RE: Request for Additional Information
Wayland Town Office Discharge Site
Transmittal No. X250635

**Town Office
Building
Groundwater
Discharge**
41 Cochituate Road
Wayland,
Massachusetts

FIGURE 4-2R2

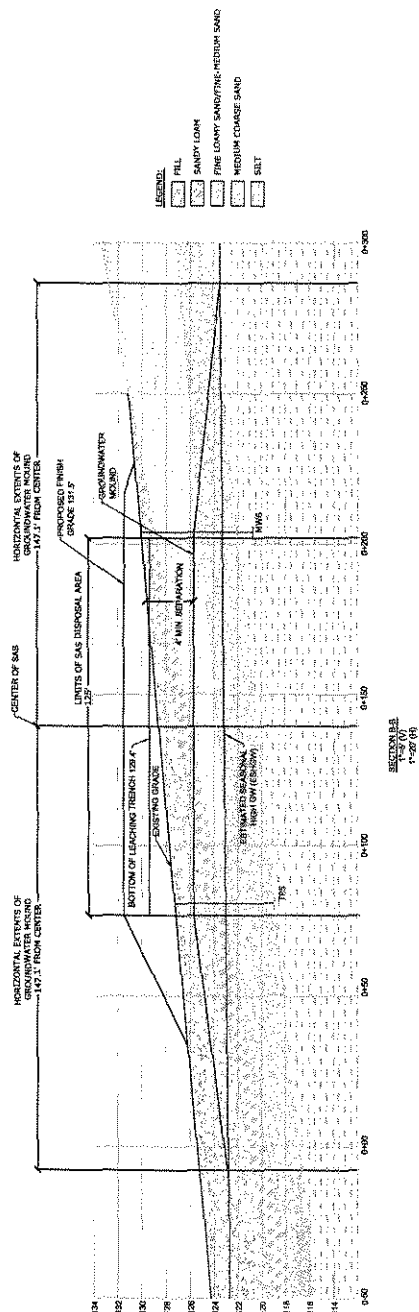
- We concur that the mounding analysis method employed is acceptable to MassDEP, however we noticed that several of the input aquifer parameters employed in the most recent mounding analysis differ from the values determined in the initial hydrogeologic report; specifically hydraulic conductivity was initially determined to be 76 feet/day and a value of 0.12 was assigned to specific yield. These values in the latest mounding analysis have been revised to 57 feet/day and 0.24 respectively. While these changes do not significantly alter the results of the mounding analysis, what is the rationale behind the change?

Based on this, all calculations submitted under this response are based on a specific yield of 0.24 ft³/ft³ and a hydraulic conductivity (K) of 76 feet/day. The groundwater mounding analysis was updated to reflect these changes. As a result, the projected groundwater mound height is 2.4 feet, approximately 0.3 feet less than submitted under the letter response. The corresponding elevations and grading have been updated to reflect this change. Attached to this letter are the following figures:

- *Figure 4-2R2 – Geologic Cross-Sections, Updated October 2012*
- *Figure 4-3R2 – Groundwater Contour Plan, Updated October 2012*
- *Figure 5-1R2 – Effluent Disposal Layout, Updated October 2012*
- *Figure 5-2R2 – Disposal Bed Profile, Updated October 2012*

These are the updated versions of the previously submitted figures, and reflect the changes based on the revised groundwater mounding calculation. Also attached is a revised version of Section 6 Conclusion which updates these results.

Septic System Analysis

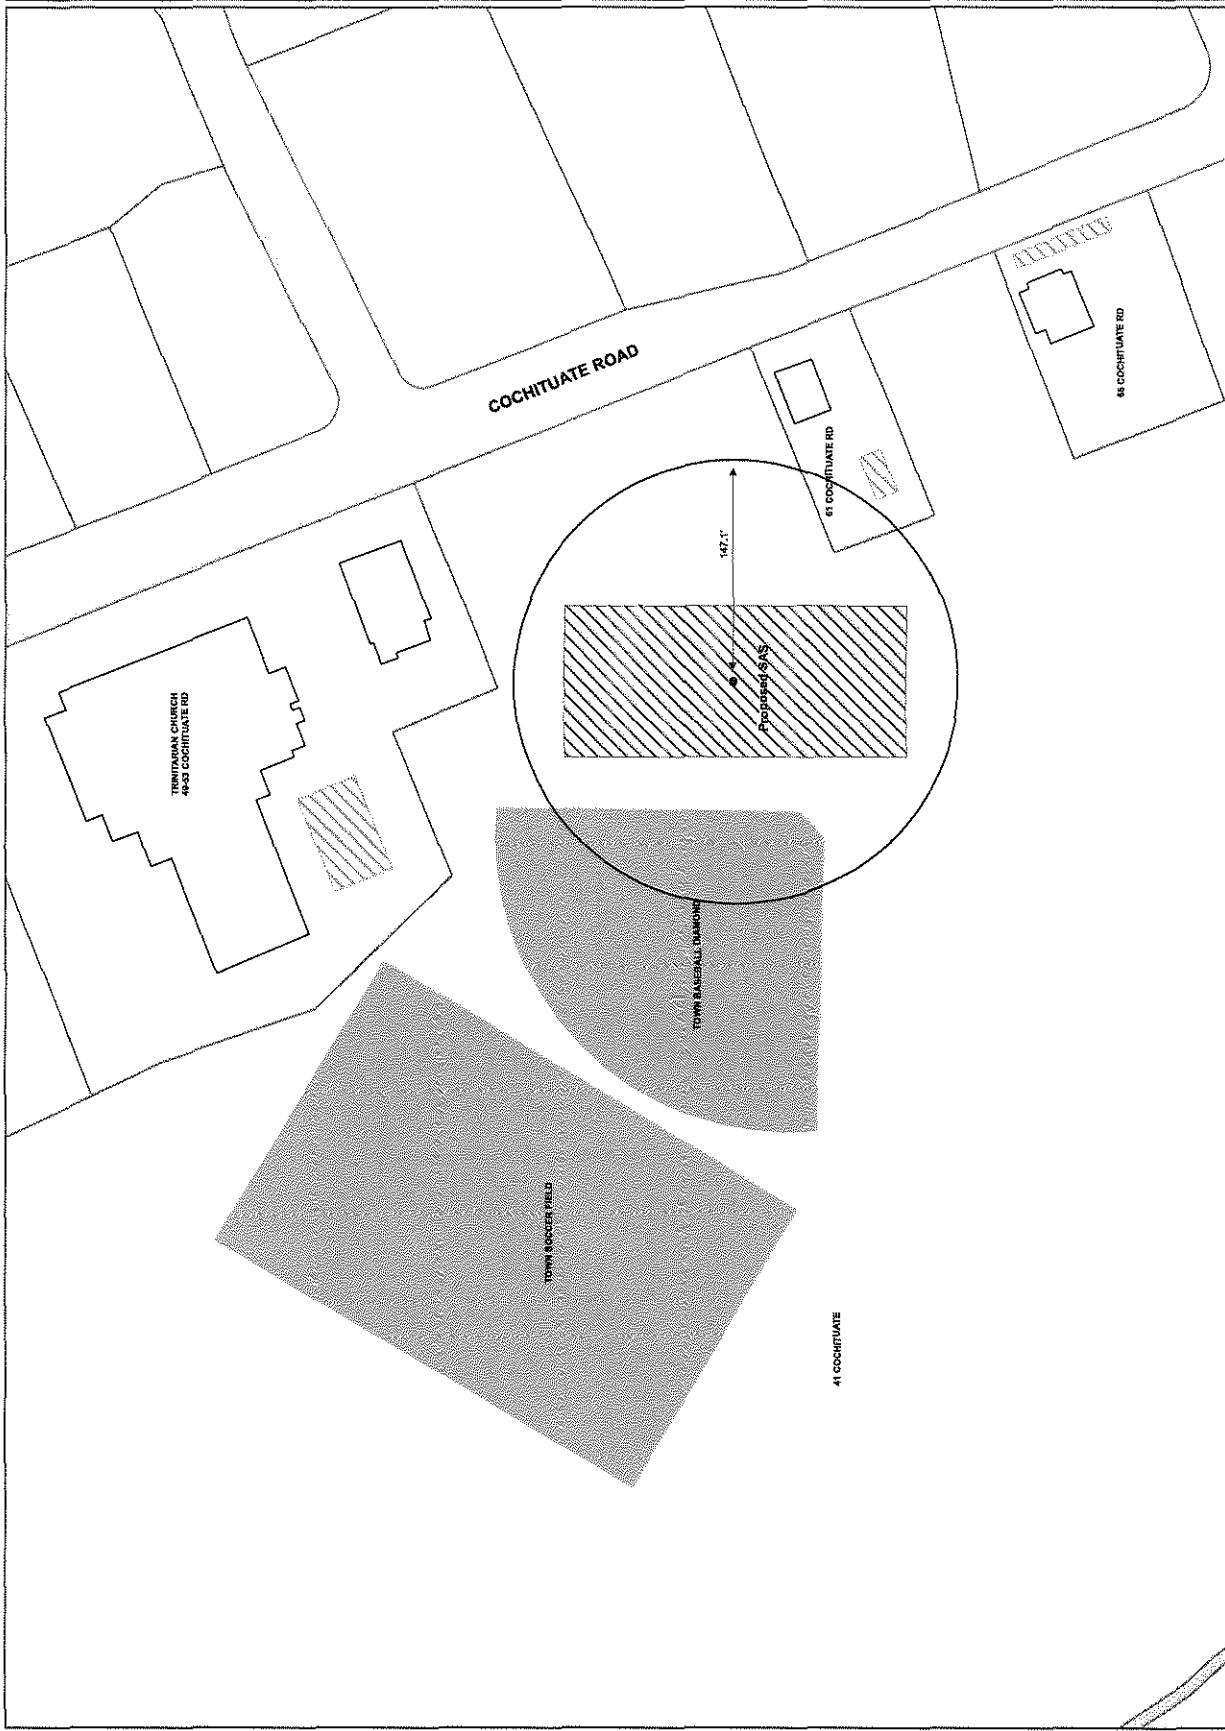
- Tighe and Bond (T&B) has determined that the aerial extent of groundwater mounding at the proposed location will be limited to 37 feet from the edge of the SAS and will not have a negative impact on the basements and septic systems of abutting properties. Kevin and I are concerned about the appropriateness of the method employed to evaluate the aerial extent of mounding and potential impacts to below grade structures and foundations. Bouwer (Hydrogeology Journal; 2002; 10:121-142) states that the method employed by T&B is appropriate when evaluating rectangular recharge basins where the length of the basin is **at least** five times the width. The length to width ratio of the proposed SAS is, however, less than half that required by Bouwer for this method.

In the same paper Bouwer proposes an alternate method for evaluating round, square or irregular shaped basins that can be represented by an equivalent circular area. While the proposed basin is not a square, its shape is arguably closer to this geometry than that of the method employed. Keeping all other parameters the same, the limit of mounding influence determined by using this method ranges from 122 feet (using a radius value of 85 feet; equal recharge area) to 369 feet (using a radius of 50 feet; half of the width of the proposed SAS). Both of these values extend mounding impacts well beyond the distance of the nearest abutting structure located approximately 50 feet north of the proposed discharge.

Given the site's shallow depth to groundwater, relatively flat water table (hydraulic gradient of approximately 0.005 ft/ft) and close proximity to abutters north of the proposed discharge, MassDEP requests that T&B reassess how abutting foundations, basements and septic systems will be impacted by the proposed discharge. MassDEP recommends that T&B contact the Wayland Board of Health to obtain all available information regarding the location and construction of septic systems, depths to groundwater and history of wet or flooded basements for all abutting properties located north and east of the proposed discharge location. T&B must adequately evaluate and assess potential hydraulic impacts to abutting sensitive receptors before a site approval letter can be issued by MassDEP.

Tighe & Bond agrees that using the Bouwer method for square or irregular shaped basins is an appropriate method for the SAS layout in Wayland. Using the revised hydraulic conductivity (K) value of 76 feet/day and an H_c feet (height of groundwater mound in center of recharge area) value of 2.4, with all other parameters the same, this results in a L_n (distance from the center of recharge area and control area) of 147.1 feet. This is the revised estimated extent of the groundwater mound from the center of the recharge area. This revised horizontal extent has been updated in all of the attached figures previously mentioned. In addition, an additional figure called Septic System Analysis has been appended to this letter to show the proposed SAS in relation to the neighboring septic systems. A circle has been drawn to show the horizontal extents of the proposed SAS, and as you will see in the figure, an emergent groundwater problem is not anticipated as there are no basements or septic systems within the horizontal extent of the groundwater mound. For your reference, the documentation obtained from the Wayland Board of Health that was used to develop this figure and locate the existing septic systems in the area has also been appended to this document.
